PUBLIC COMMENT FORM

PROJECT NAME: KIRKMOND PRELIMINARY PLAT

FILE NUMBER: LAND 2013-00280

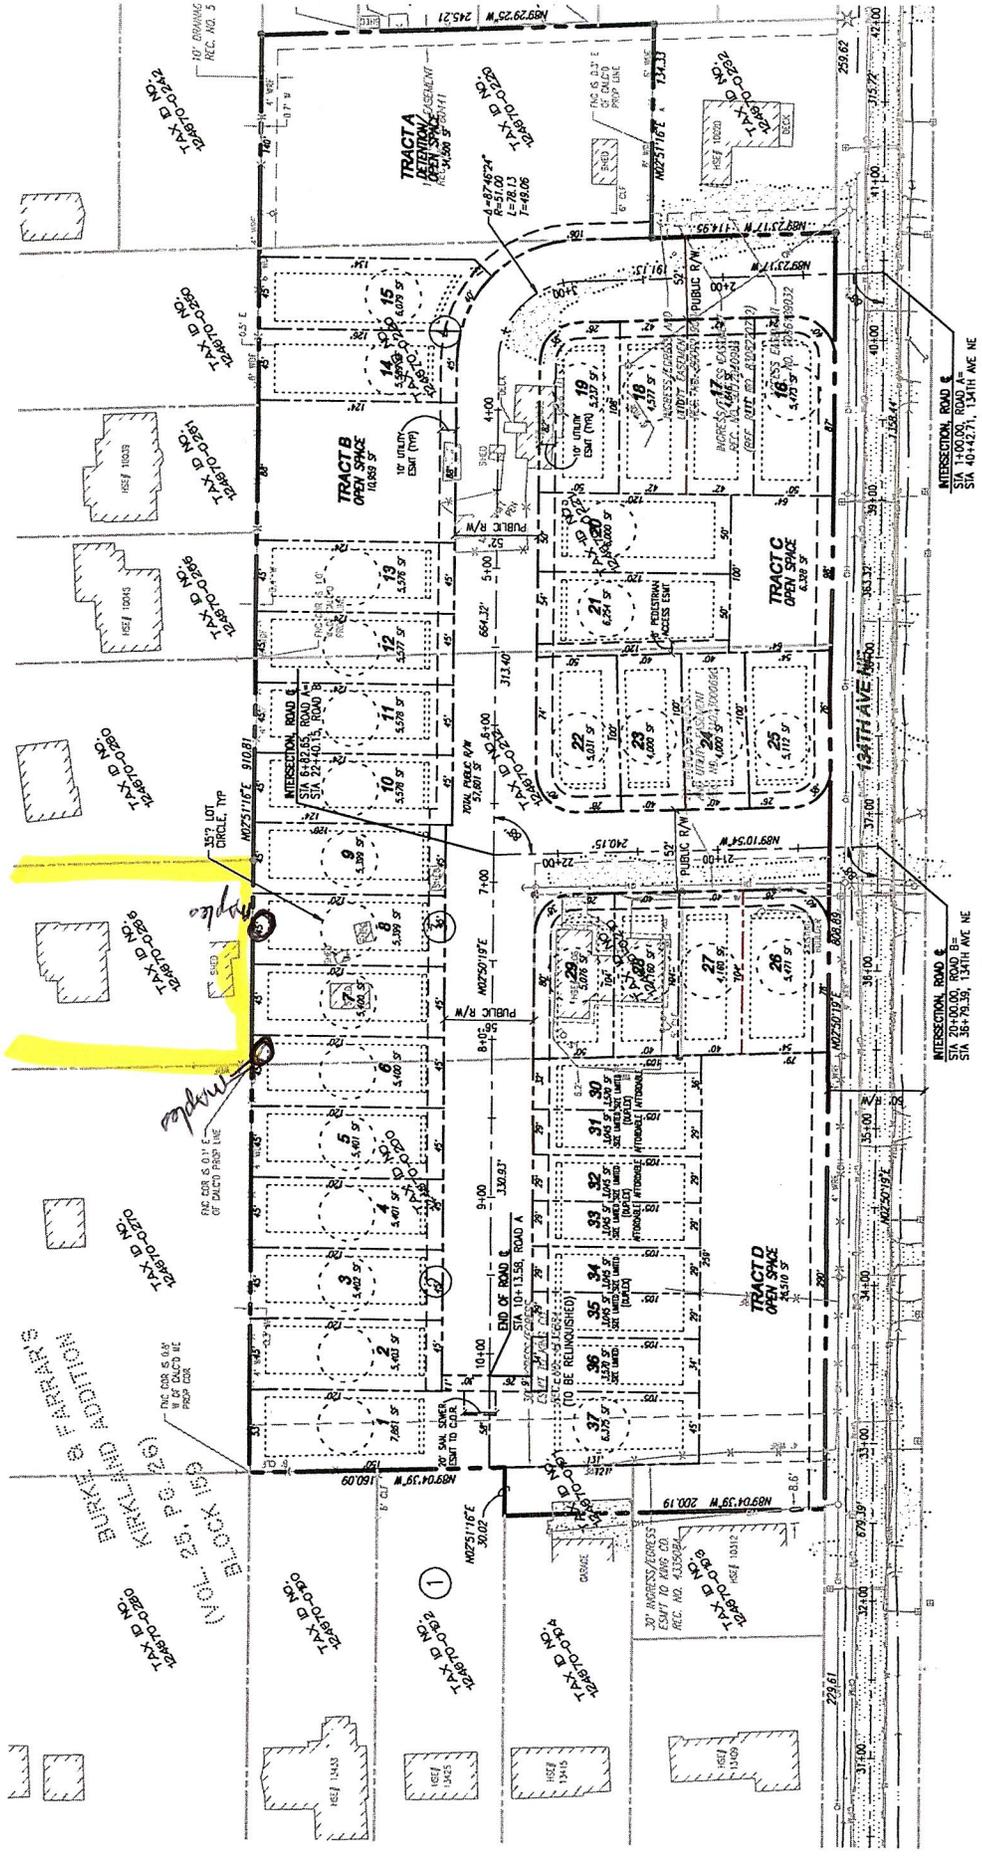
Re: Landscape plan for subject development. Please consider the removal (approval) for 2 giant maple trees as indicated on attached plan. These trees are a nuisance every fall and cause me time + money to clean up after the leaves and debris.
